UNITED STATES
NUCLEAR REGULATORY COMMISSION
WASHINGTON, D. C. 20555

APPLICANT: Public Service Electric & Gas Company (PSE&G)
FACILITY: Hope Creek Generating Station
SUBJECT: SUMMARY OF STRUCTURAL AND GEOTECHNICAL ENGINEERING
BRANCH (SGEB) MEETING

On August 1, 1984, a meeting was held in the Bethesda, Maryland offices of the NRC to discuss the remaining SGEB-Structural audit open items identified in the Draft SER. A list of meeting attendees is included as Enclosure 1 to this meeting summary.

FIGURE A-13-32
RESPONSE SPECTRA COMPARISON,

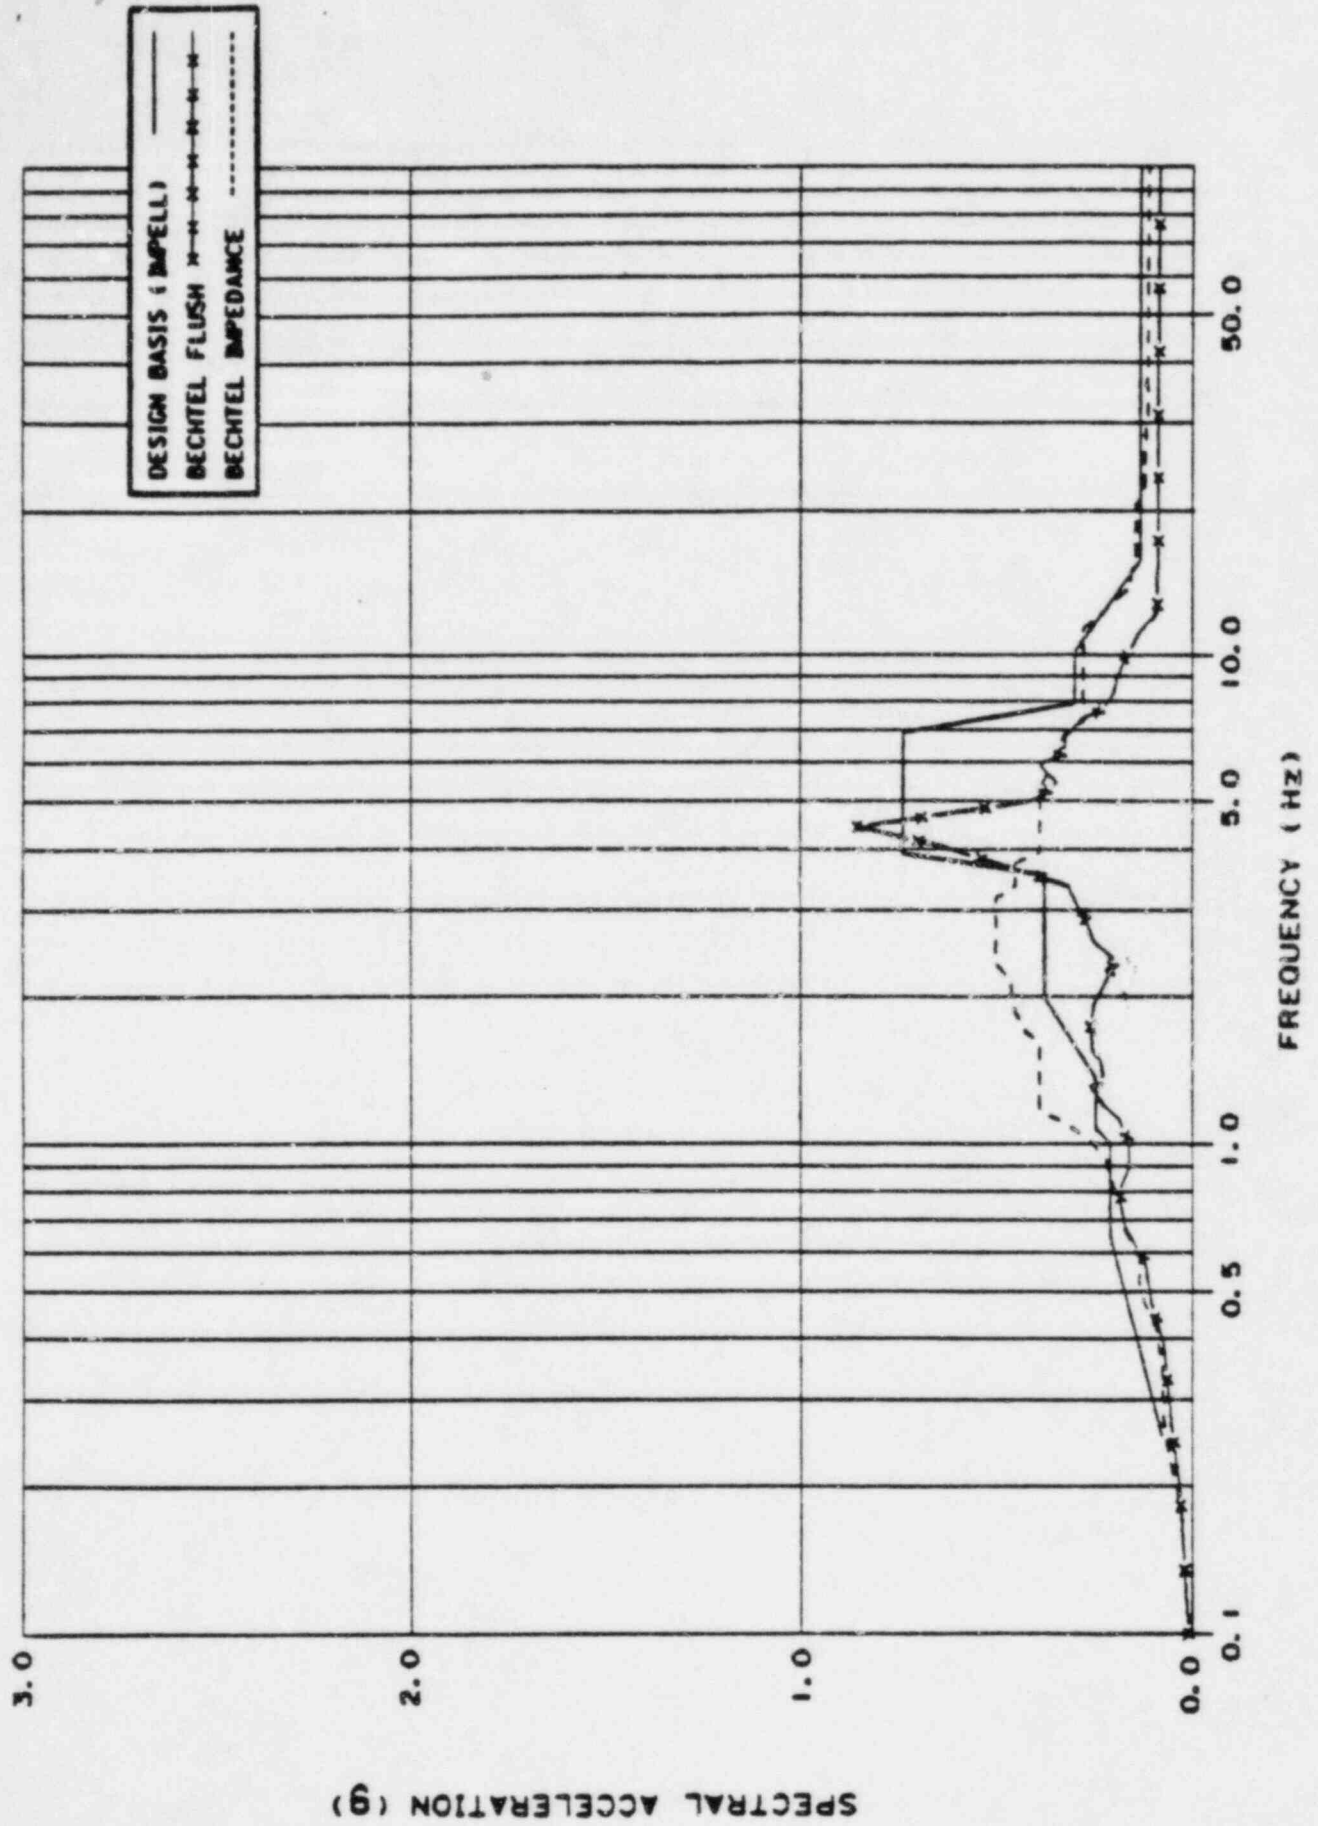
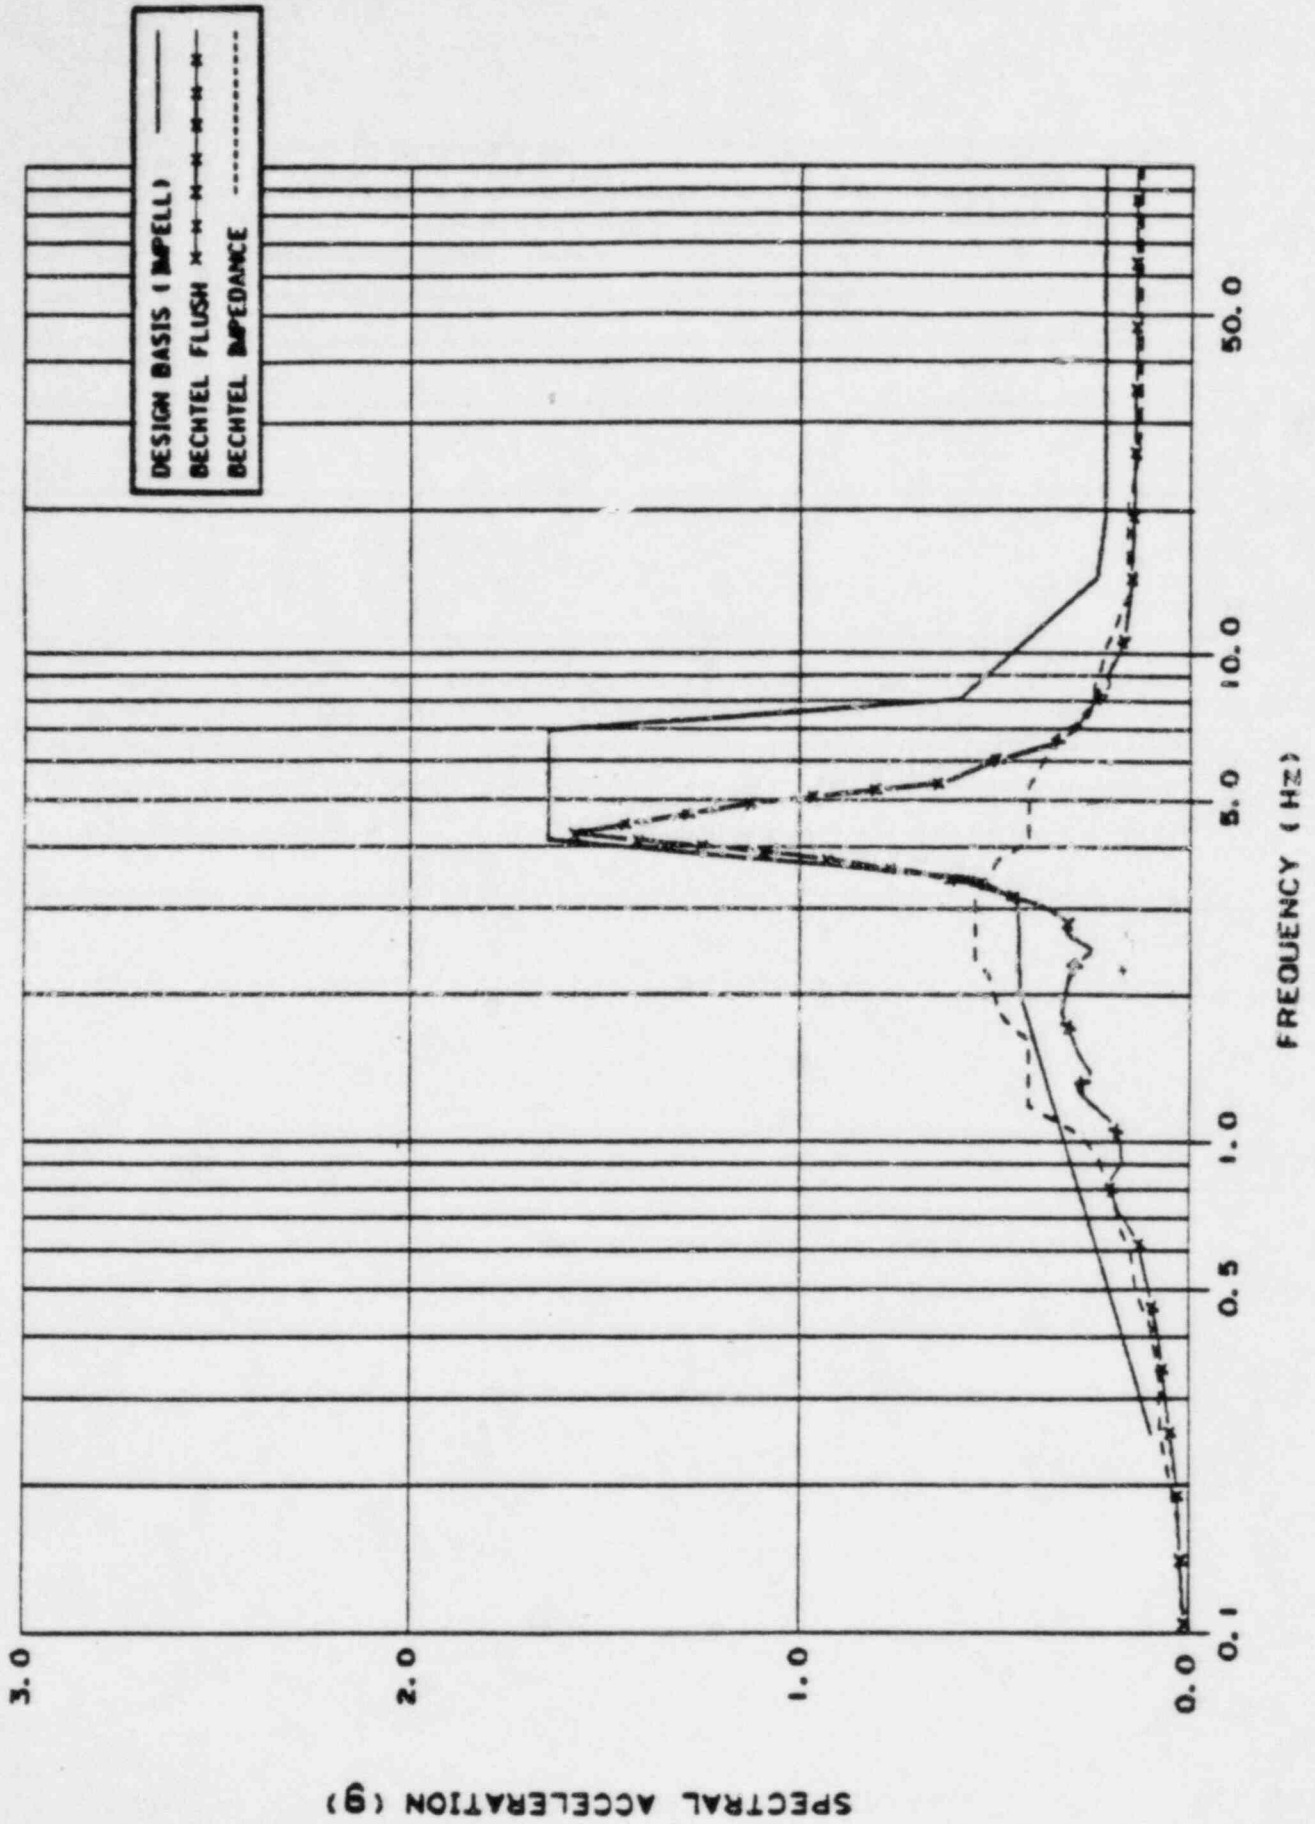
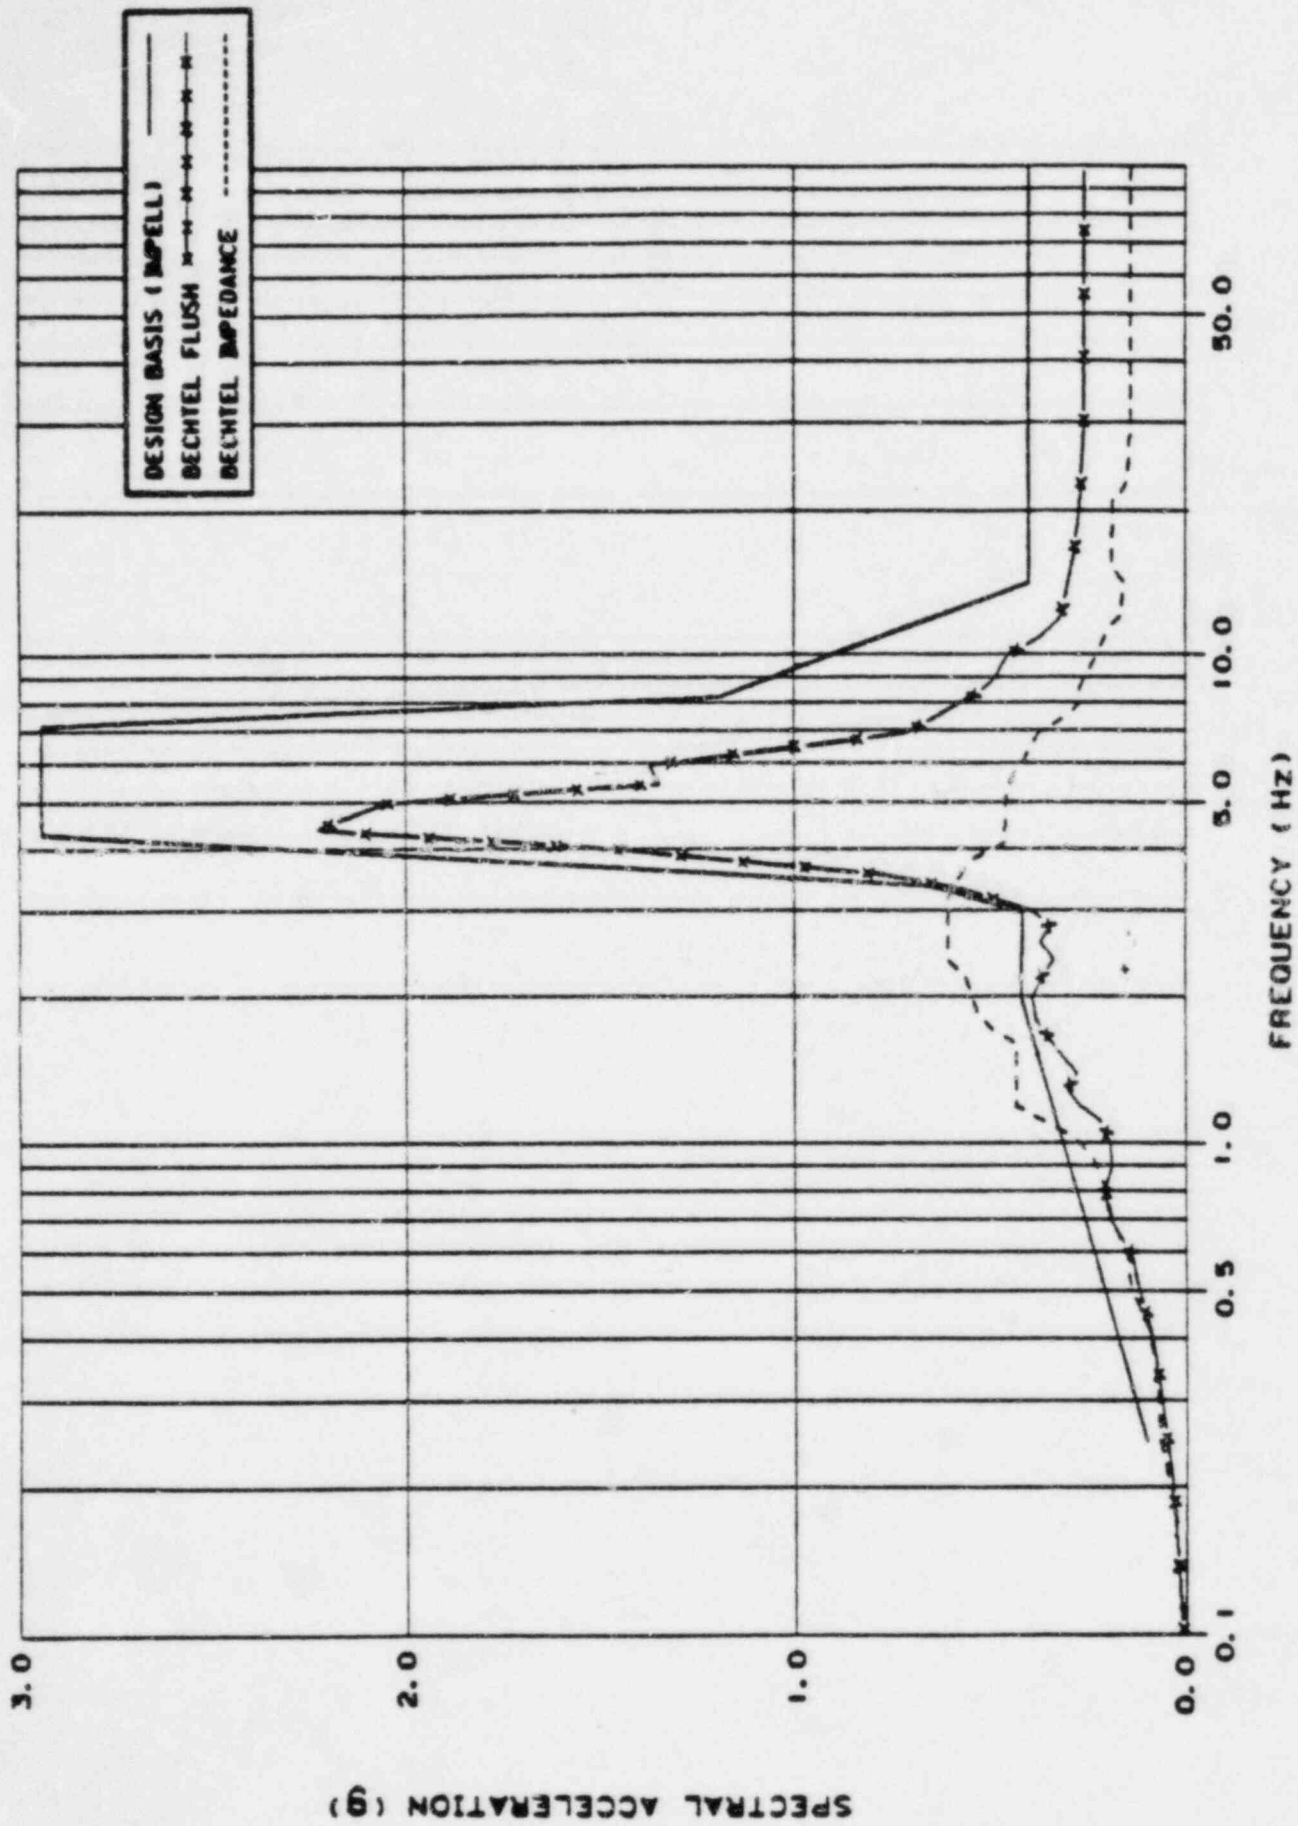
Question: Provide comparison of Bechtel Independent Verification Results with the Design Basis Results.

Figures A-13-2 to A-13-37 show the comparison of the response spectra (2% damping) obtained from the above three seismic soil-structure interaction analyses. Discussions of these comparisons are as follows:

Bechtel's independent soil-structure interaction analyses are performed using the computer code FLUSH. The results of independent finite element analyses are in reasonable agreement with those of the design basis analyses. As can be seen from Figures A-13-2 through A-13-37, the horizontal response spectra obtained from the independent finite element analyses are generally enveloped by those obtained from the design basis analyses except for the frequency range lower than 2 Hz. The vertical response spectra showed some exceedances at the frequency range of 18 Hz. These exceedances are listed in Table A-13-1.

The peak spectral accelerations obtained from the impedance approach analyses are generally lower than those obtained from the design basis analyses. However, these response spectra are not completely enveloped by those obtained from the design basis analysis, especially in the frequency range between 1.0 and 3.5 Hz. Also, there are some local exceedances in the higher frequency range, as shown in Figures A-13-2 through A-13-37.
